Art Commission Review – Submittal Form

Project Name: Finley Rec Center - Site Improvements

Reference: Request for Final Approval – Finley Recreation Center, Site Improvements

FINLEY RECREATION CENTER
SITE IMPROVEMENTS
7701 MANSFIELD AVENUE, PHILADELPHIA, PA

CANOPY COVER, SITE FURNISHINGS & UTILITY LOCATIONS

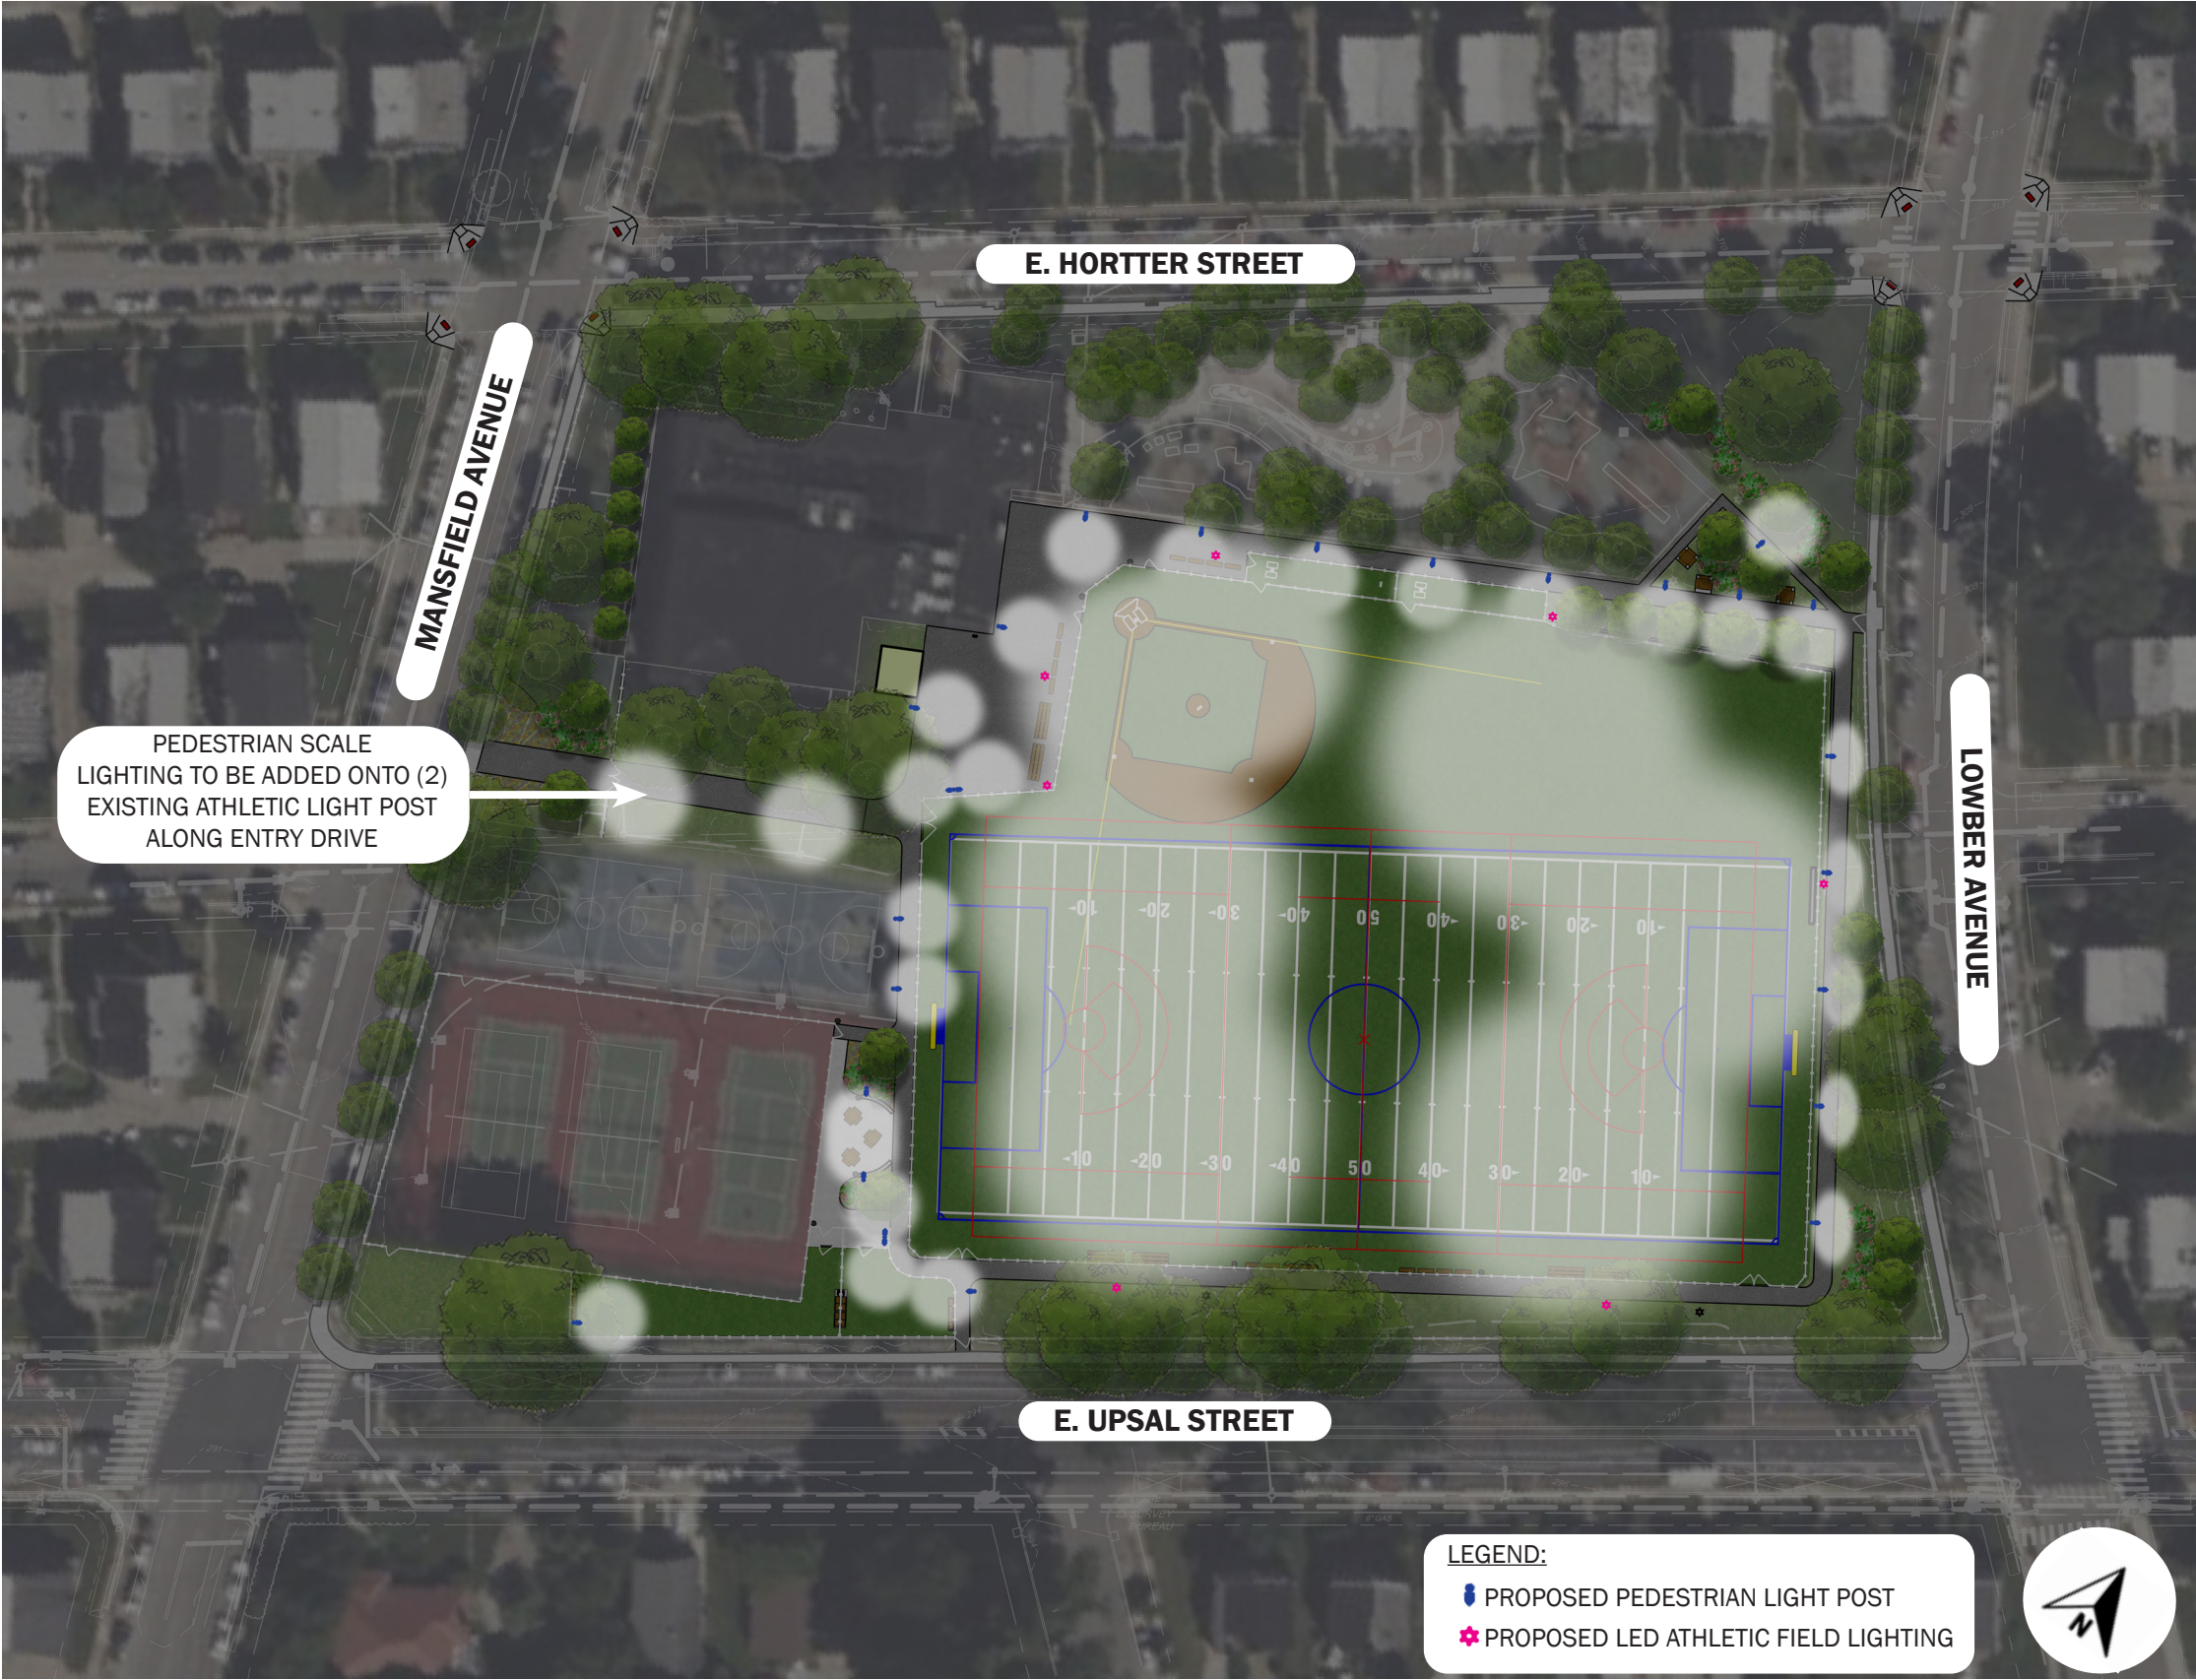
A color-coded site plan slide has been added delineating locations of existing trees to remain, where new site furnishings and trees are proposed, and where utility constraints are present. The site design has also been updated to include three (3) additional fixed tables with game tops in the northeast corner of the site where a significant increase in tree canopy is proposed, this will provide an additional shaded seating area for visitors to the site. Two (2) additional backed benches have also been added to the dog park, one (1) in each area. An additional presentation slide has been added, further clarifying where specific site furnishings are proposed on site.
